Viking CCS Pipeline

9.6 Design Changes 1 and 2: Environmental Technical Note

Document Reference: EN070008/EXAM/9.6

Figure 3 (2 of 3)

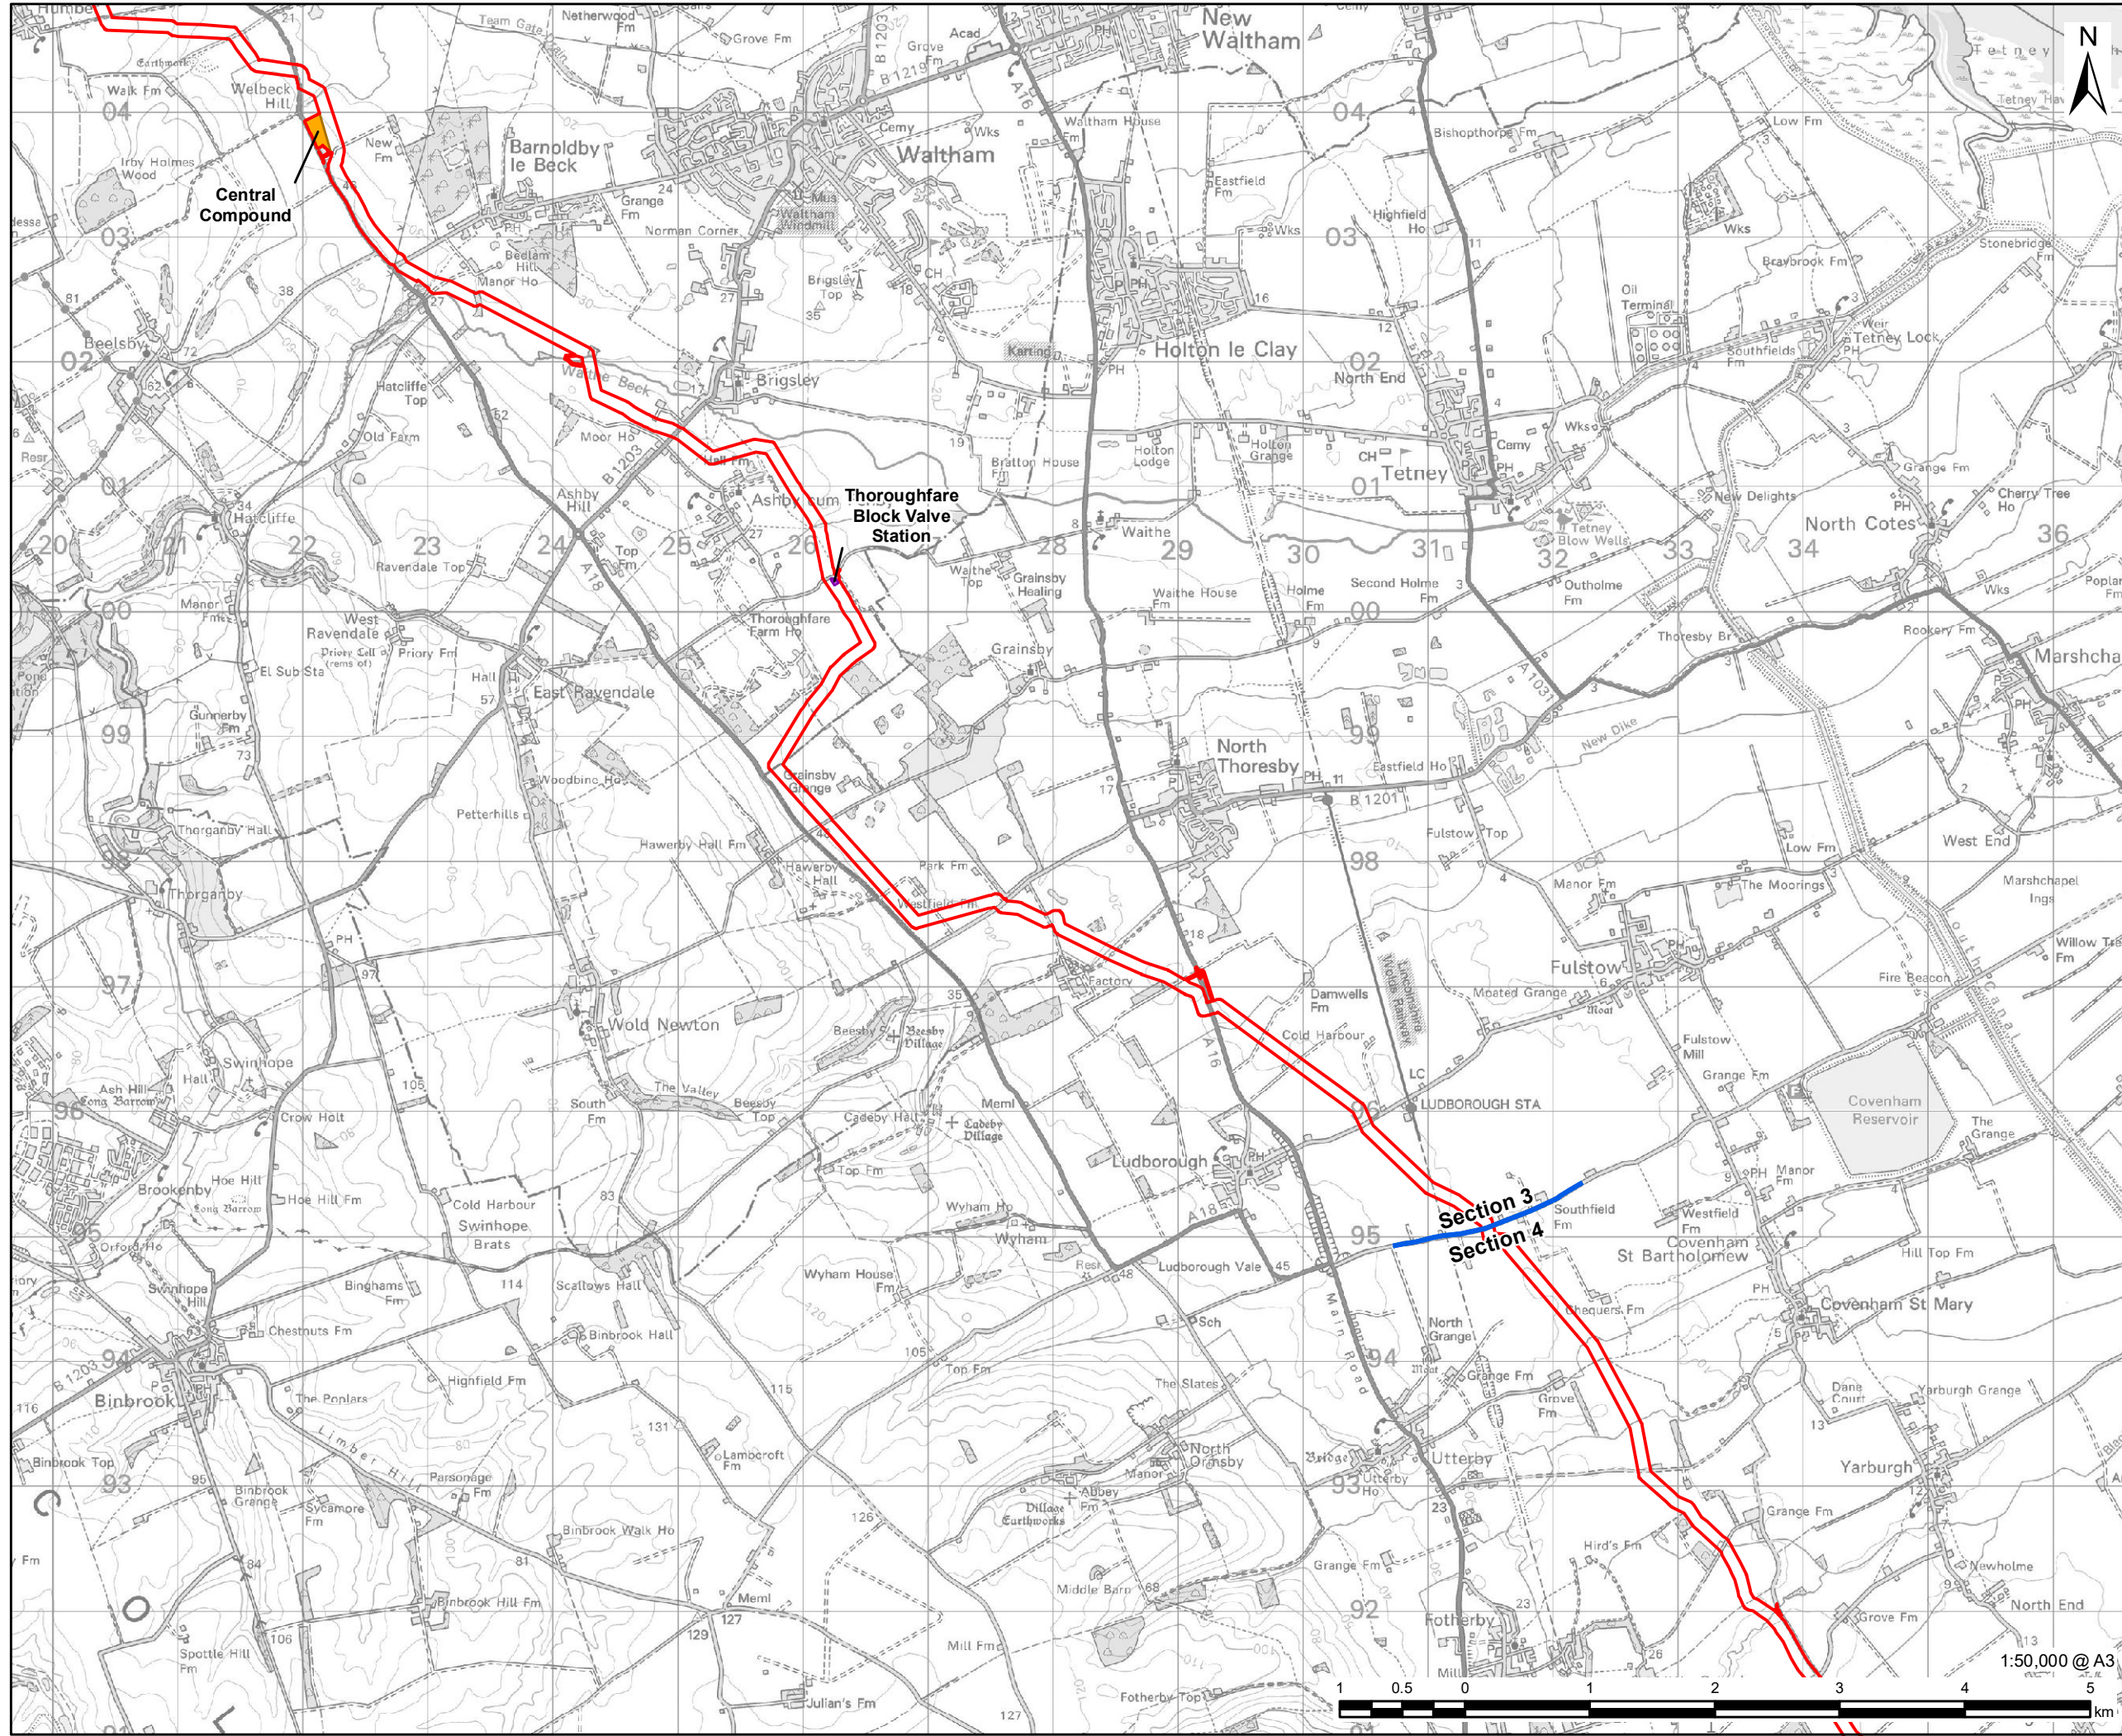
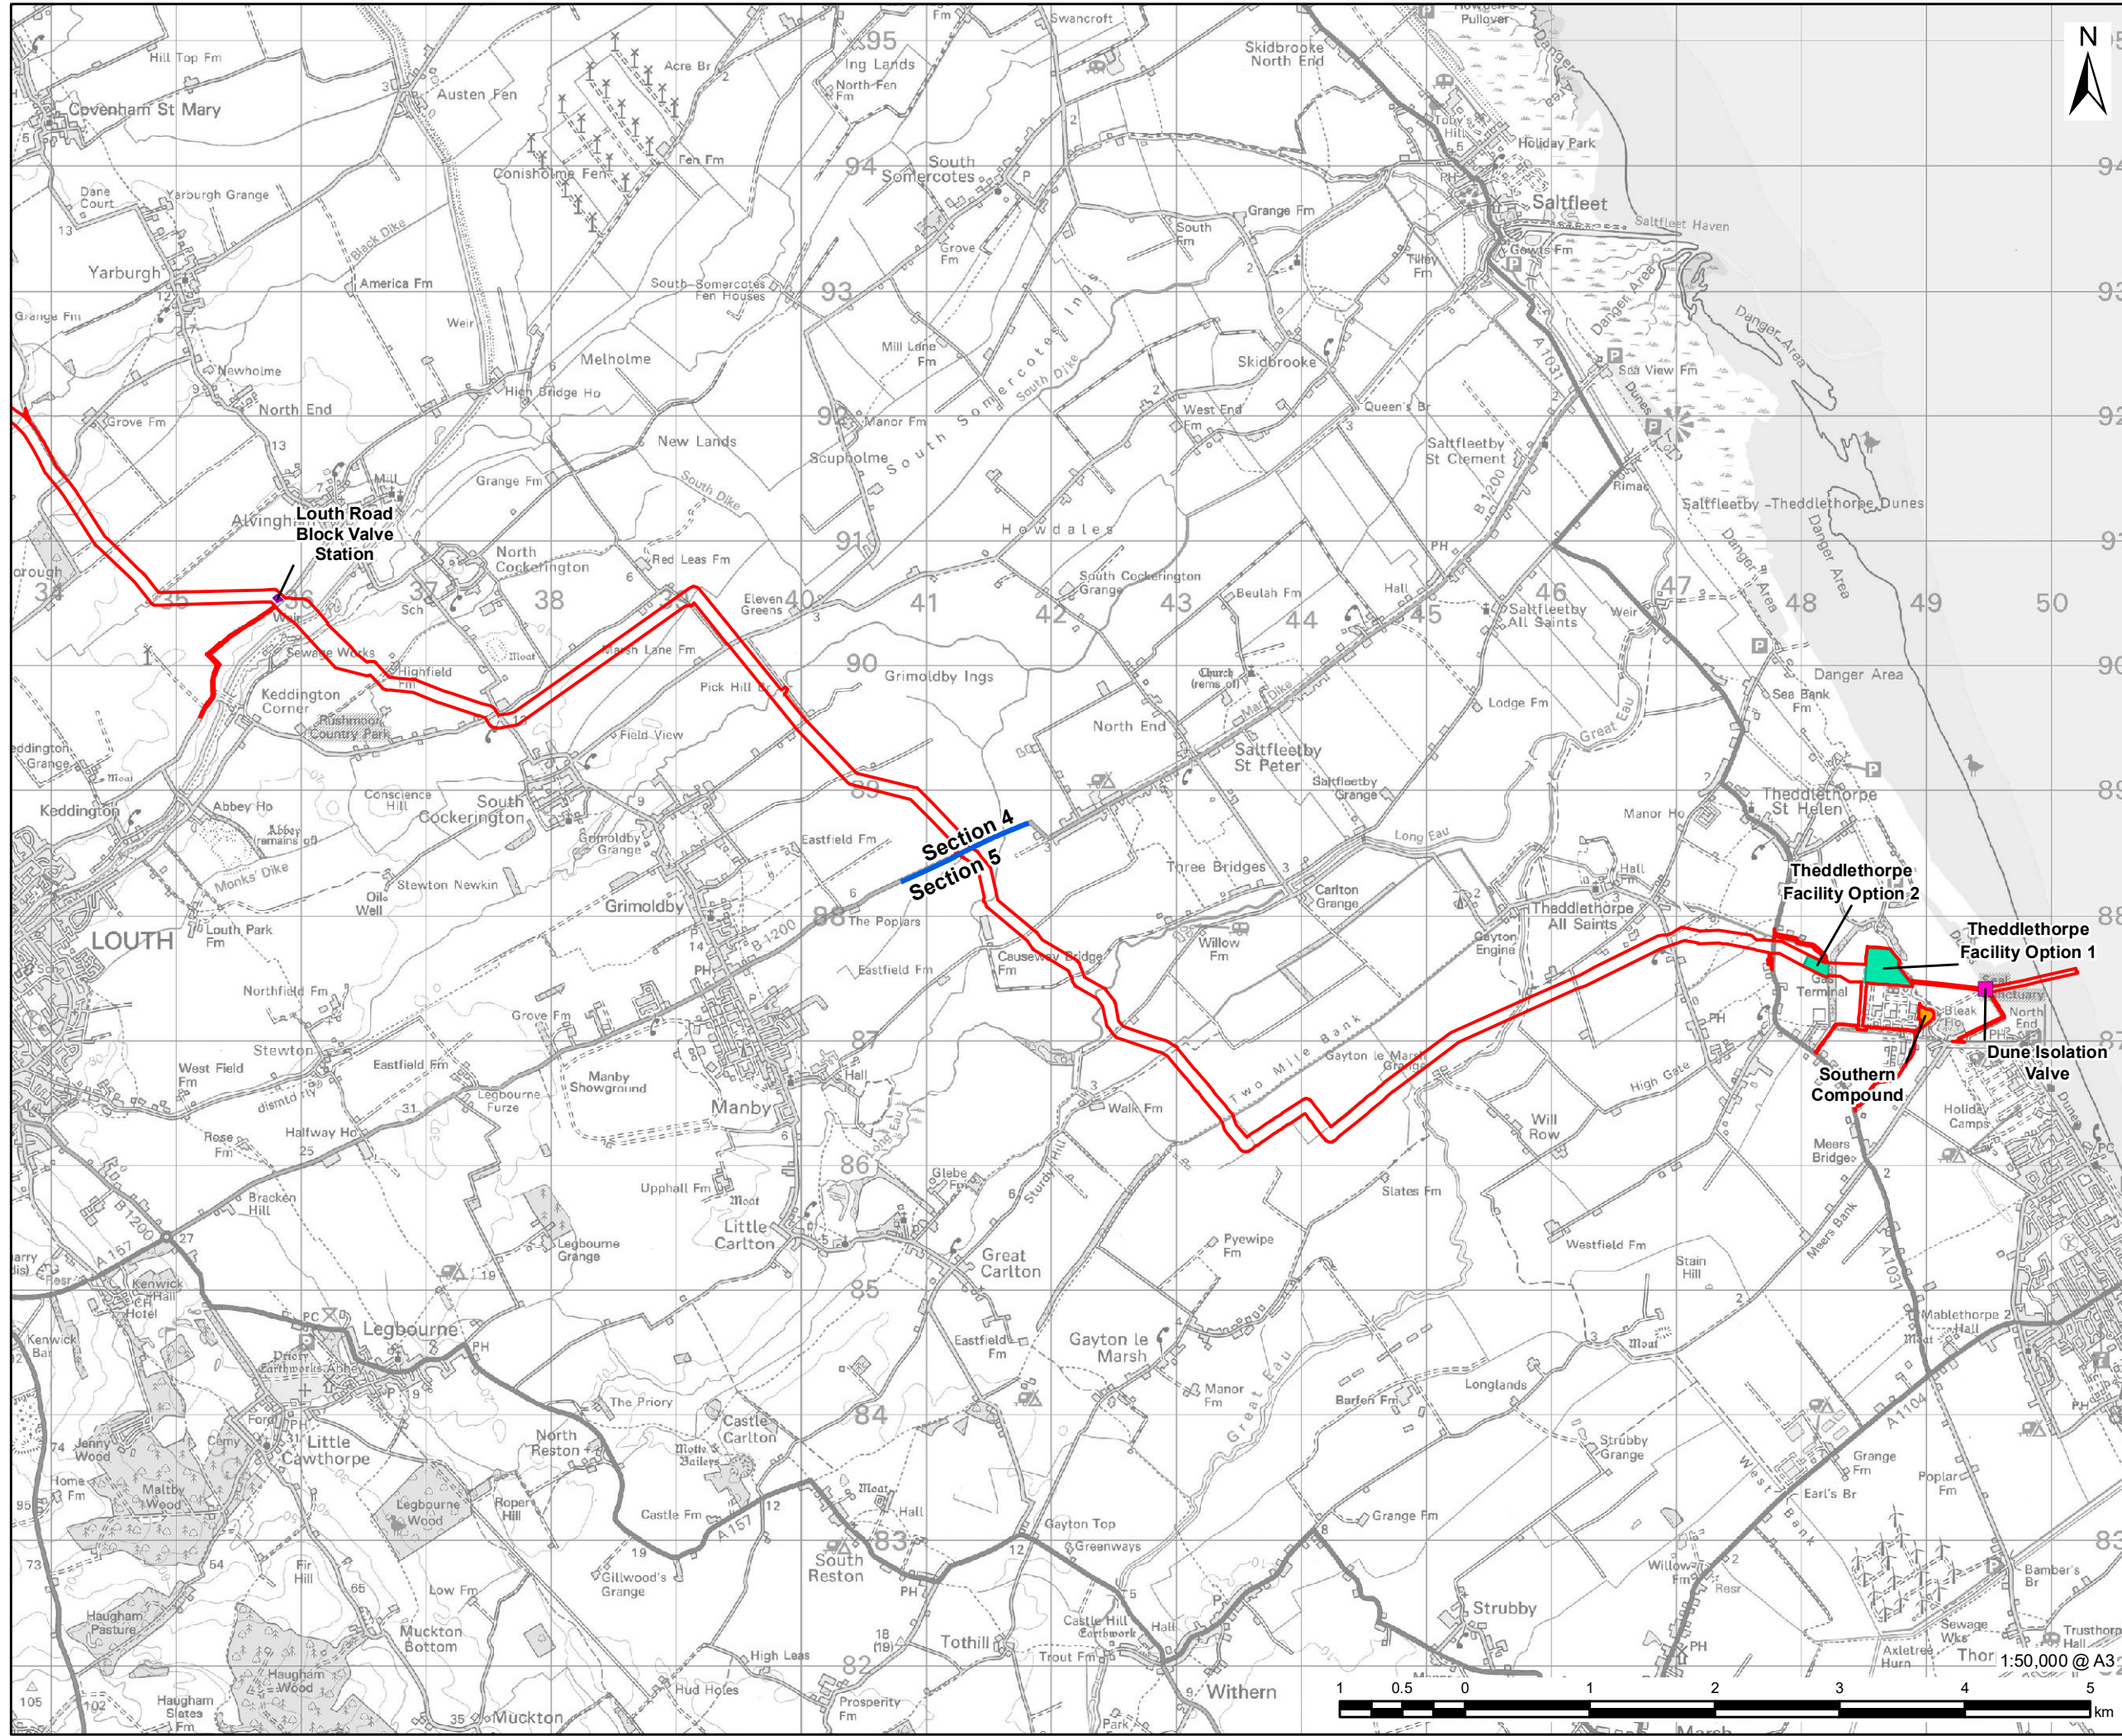
2.4.1 **Figure 3** presents the update Order Limits/DCO Site Boundary for the Proposed Development taking into account the proposed Design Change 1 and Design Change 2.
